Addendum No. 1 to an Environmental Impact Report

Addendum No. 1 to the Environmental Impact Report for the Sycamore Canyon Business Park Buildings 1 and 2 Project (State Clearinghouse No. 2015081042; Project) has been prepared by the City of Riverside Planning Division (“City”) in conformance with the California Environmental Quality Act (Public Resources Code, § 21000 et seq.) (“CEQA”), the *CEQA Guidelines* (Cal. Code Regulations, Title 14, Chapter 3 § 15000 et seq.) and the City of Riverside Resolution No. 21106 (Local CEQA Guidelines), to address minor changes to construction methodology of the Sycamore Canyon Business Park Buildings 1 and 2 (described below) to include limited blasting on portions of the Project site.

Figure 3 - Blasting Activity Locations
 Sycamore Canyon Business Park Buildings 1 and 2
 EIR Addendum No. 1

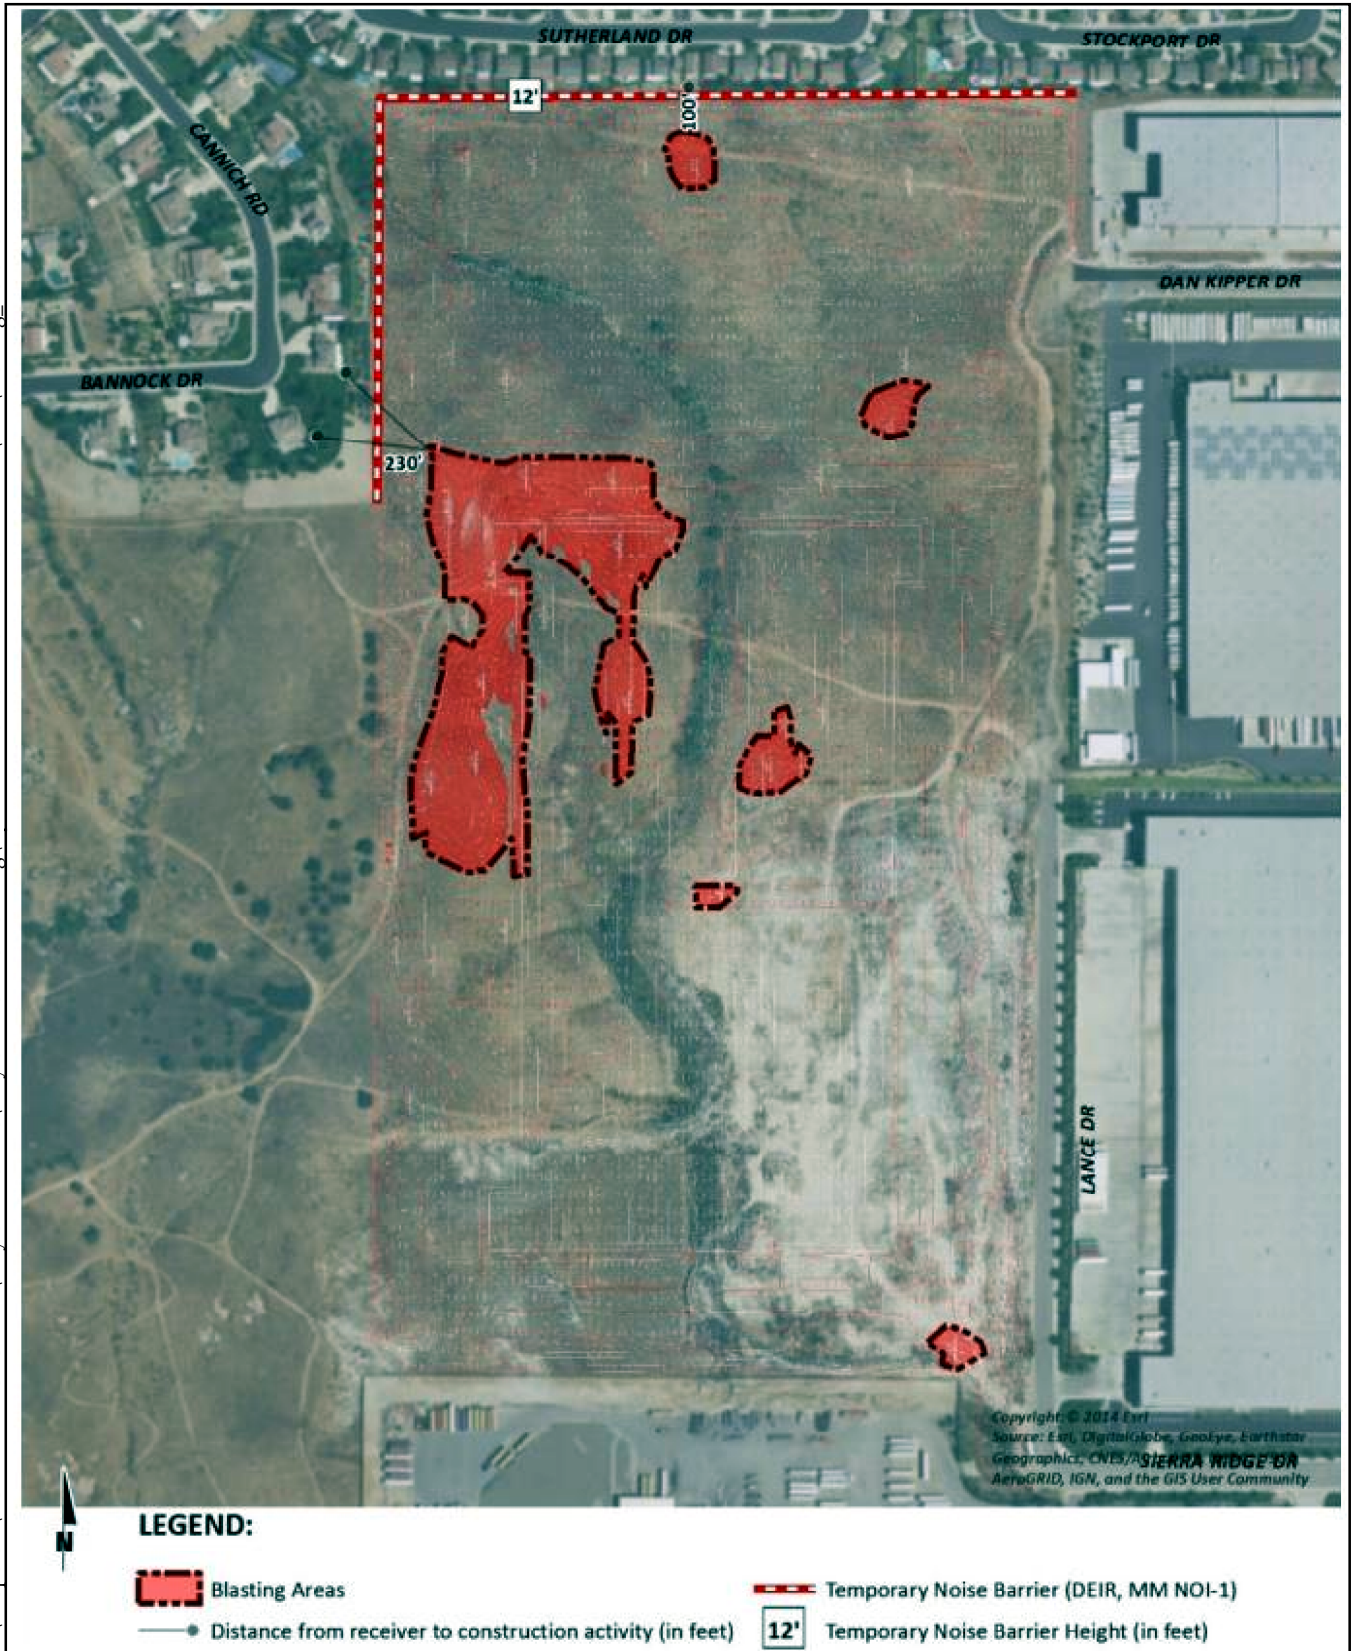
The Project Applicant plans to engage in additional meetings and coordination with residents to the north and west of the Project site regarding minor changes to the Project's approved construction methodology (i.e. mechanical grading) and mitigation measure **MM NOI 12**. In order to reduce the amount of time mechanical grading equipment will be in use in certain areas of the Project site, the Project Applicant is proposing blasting activities in the areas shown on **Figure 3 – Blasting Activity Locations** during the grading phase of Project construction.

The Project Applicant is proposing blasts would occur at the edge of the blasting areas identified in **Figure 3 – Blasting Activity Locations**. Based on information provided by the Project Applicant and blasting contractor (California Drilling and Blasting Co., Inc.), blasts will be below-ground and will be partially, if not substantially, contained, depending on the depth of the hard rock areas within the Project site. Blasting at the Project site is anticipated to occur during the grading stage of Project construction, which is estimated to last for roughly 60 days, with approximately seven to nine blasting events necessary to break the hard rock within the site. A blasting event is comprised of multiple charges that are set off at one time. Each blasting event is over within seconds and the events are spaced out over days to weeks apart. Alternative rock-breaking methods, if used, would be anticipated to result in a longer grading period of 122 days, with 47 days of rock-breaking activities including the use of excavators and impact hammer equipment. (Refer to Appendix A of this Addendum).

MM NOI 12: During grading activities, ~~No-no~~ blasting shall take place on the Project site except for the areas depicted in Figure 3 of Addendum No. 1 to the Environmental Impact Report for the Sycamore Canyon Business Park Buildings 1 and 2 Project. No other construction equipment shall operate during each blast in the blast area, but can commence operation once the blasting contractor indicates it is safe to do so.

EXHIBIT A: BLASTING ACTIVITY LOCATIONS

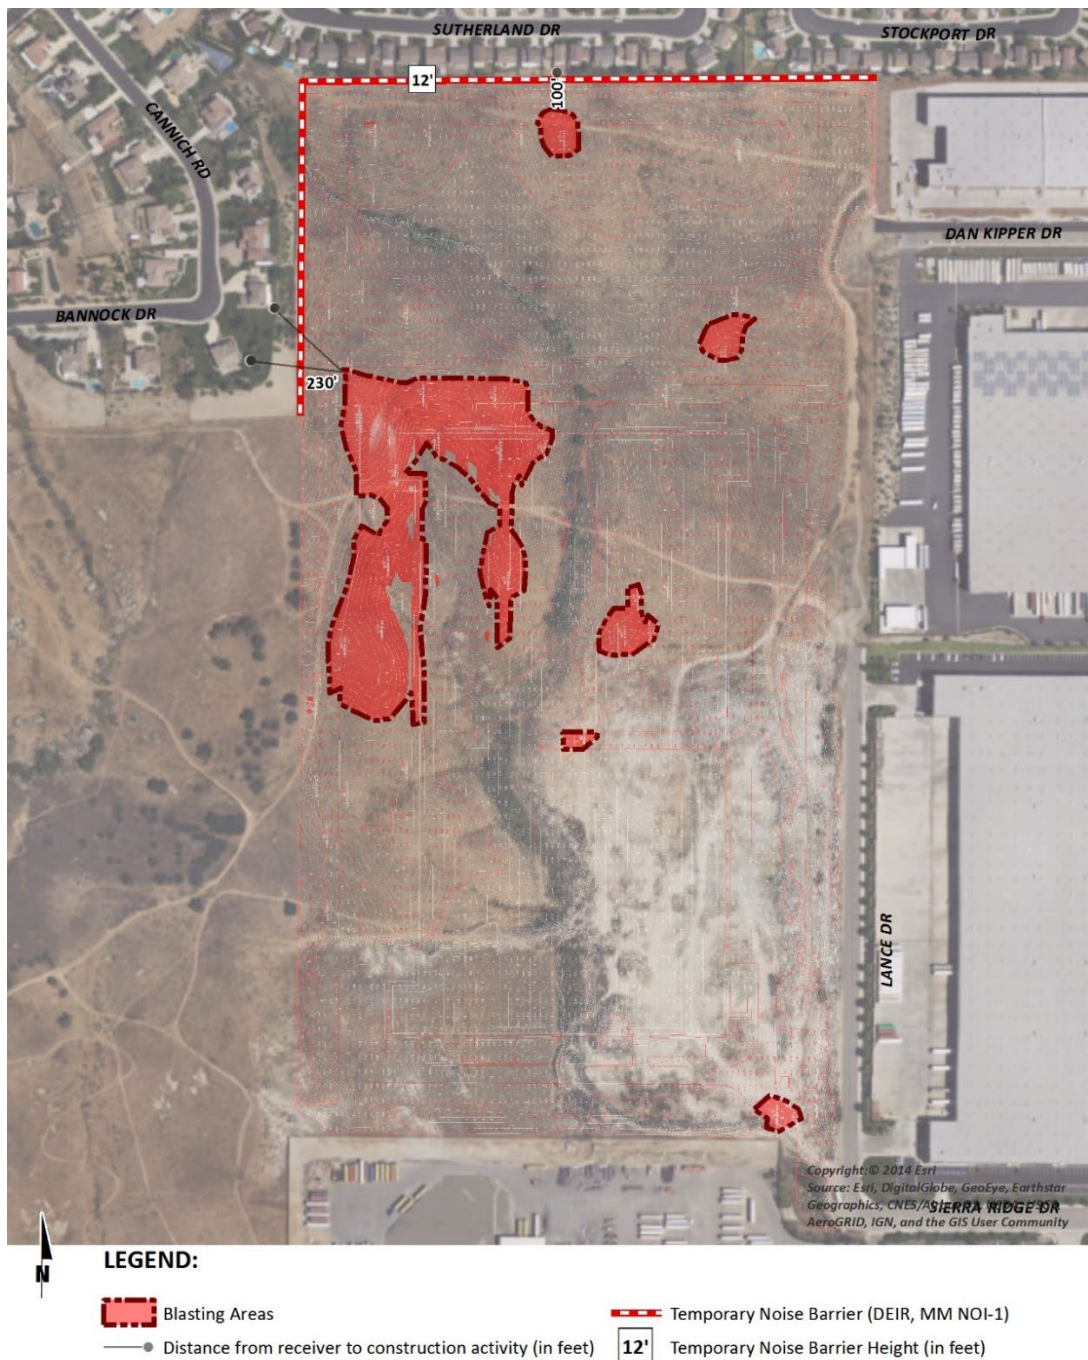
The Project includes potential blasting activities in the areas shown on Exhibit A, based on the November 14th, 2017 *Sycamore V Hard Rock Exhibit* prepared by Boberg Engineering & Contracting, Inc. (3) To present a conservative approach, this analysis assumes that blasts would occur at the edge of the blasting areas indicated on Exhibit A. Based on information provided by the Project Applicant and the blasting contractor, California Drilling and Blasting Co., Inc., the blasts will be below-ground and will be partially, if not substantially, contained, depending on the depth of the hard rock areas within the Project site. Additional information provided by the blasting contractor, including calculation parameters, is included in the vibration and airblast calculations in Appendix A.

Table 1 shows the calculated vibration levels for the worst-case (closest) blast locations near the adjacent residential homes north and west of the Project site. The vibration levels of Project blasts are expected

to range from 0.35 to 0.37 in/sec PPV based on the distances to nearby residential homes, previously shown on Exhibit A. Calculations for both the northern and western blasting areas are provided in Appendix A.
